REMARKS

Appl. No. 10/601,532
Amdt. Dated July 26, 2005
Reply to Office Action of January 26, 2005

FIG 1

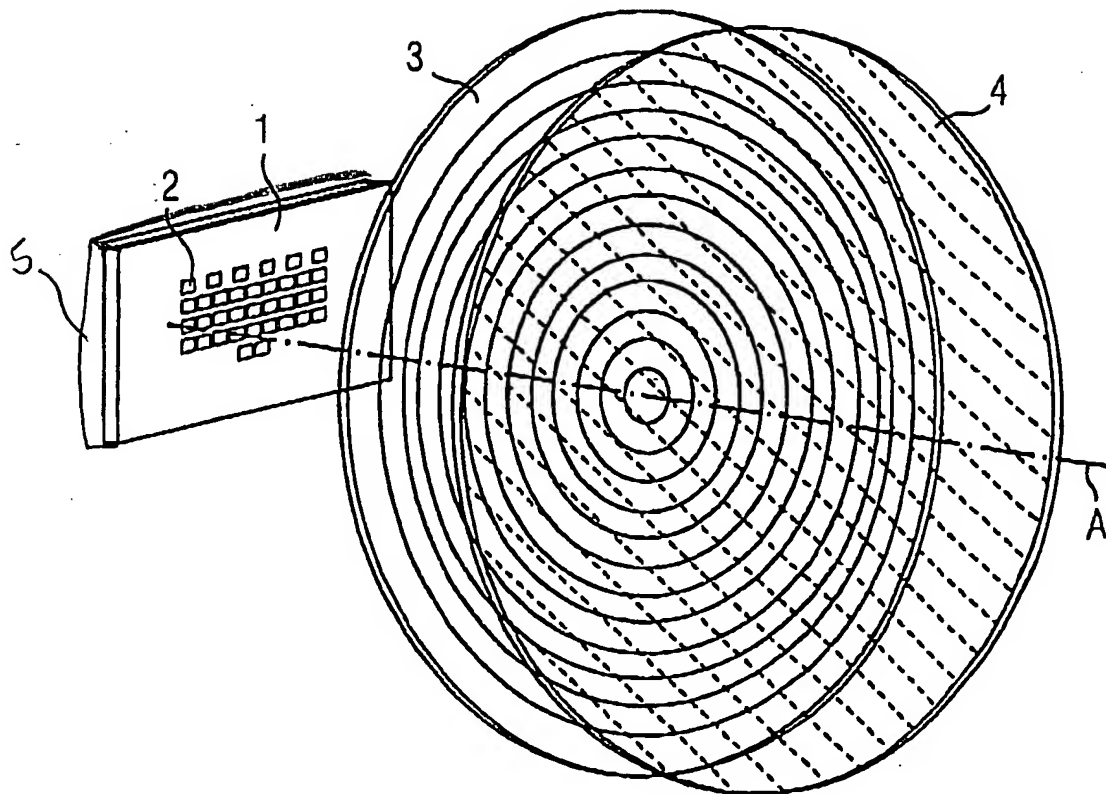
Under the heading "Drawings" on page 2 of the Office Action, the Examiner objected to the drawings for not showing the heat sink recited in claims 13 and 31. Fig. 1 has been amended to show the heat sink 5. The specification has been amended to recite the reference numeral 5 for the heat sink on page 11 of specification.

The attached sheet of drawings includes changes to Fig. 1. This sheet which includes Figs. 1-2, replaces the original sheet including Figs. 1-2. In Fig. 1, a heat sink 5 was added.

Please approve the drawing changes that are marked in red on the accompanying "Annotated Sheet Showing Changes" of Fig. 1. A formal "Replacement Sheet" of amended Fig. 1 is also enclosed.
